**RE: Plan Approval for Conventional LPD, Biggins Property, Clarksville Ridge, Lot 44
6726 Surrey Lane, Clarksville, MD 21029**

At the request of your staff, I have assisted in the evaluation, review and approval of the design plans which are most recently dated 7/17/09 prepared by Tom Ashton, R.S./CPSS for a conventional low pressure dosed system with advanced pretreatment to serve the above referenced property.

RE: **Biggins Property**
Clarksville Ridge, Lot 44
6726 Surrey Lane
Clarksville, MD 21029

LOW PRESSURE DOSING
SEWAGE DISPOSAL SYSTEM
6726 Surrey Lane

TRENCH PROFILE

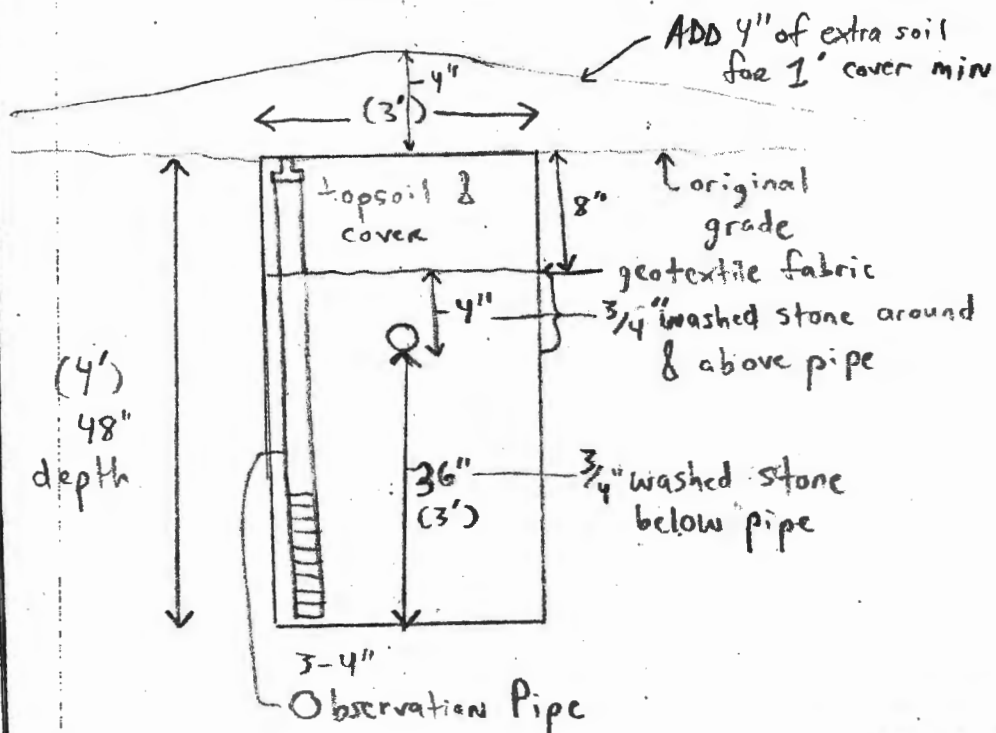
width 36" (3')
